ASSESSMENT REPORT

West Cliff Coal Mine – Surface Goaf Gas Drainage Project Section 75W Modification (MP 07_0073 MOD 1)

Figure 1: Layout of wells for Longwall 34, approved and proposed.

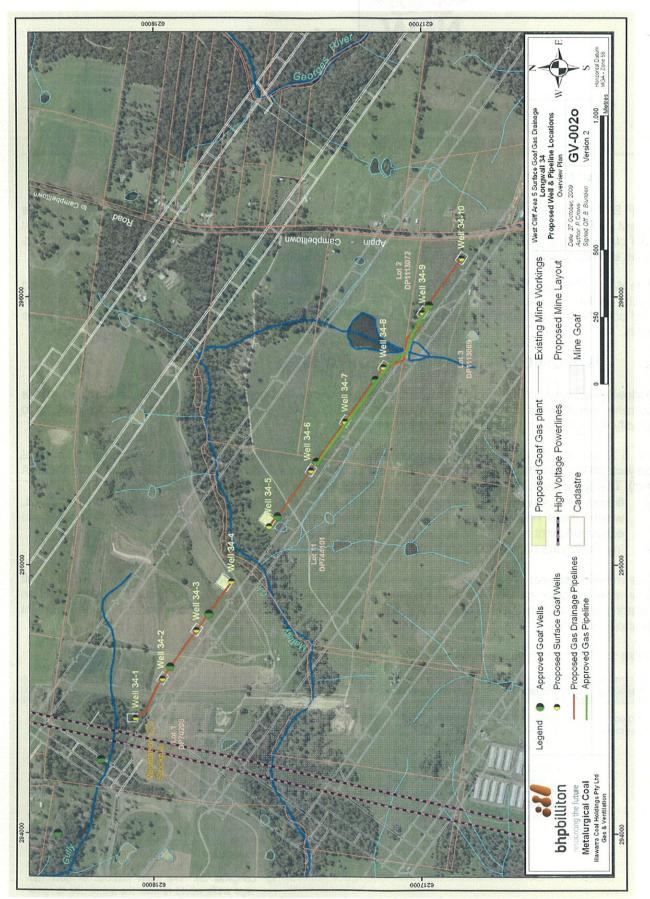
On 5 November 2009, Illawarra Coal submitted an application to the Department, seeking to modify the project (MP 07_0073) under Section 75W of the *Environmental Planning and Assessment Act 1979* (EP&A Act). The proposed modification (see Figure 1) comprises the following components:

- linking the proposed gas extraction wells via a surface pipeline to one of two centralised locations, which would host an extraction plant and flare/vent stack, rather than consecutively locating an extraction plant and a flare/vent stack within each well compound, and
- increasing the number of wells for Longwall 34 from 8 to 10.
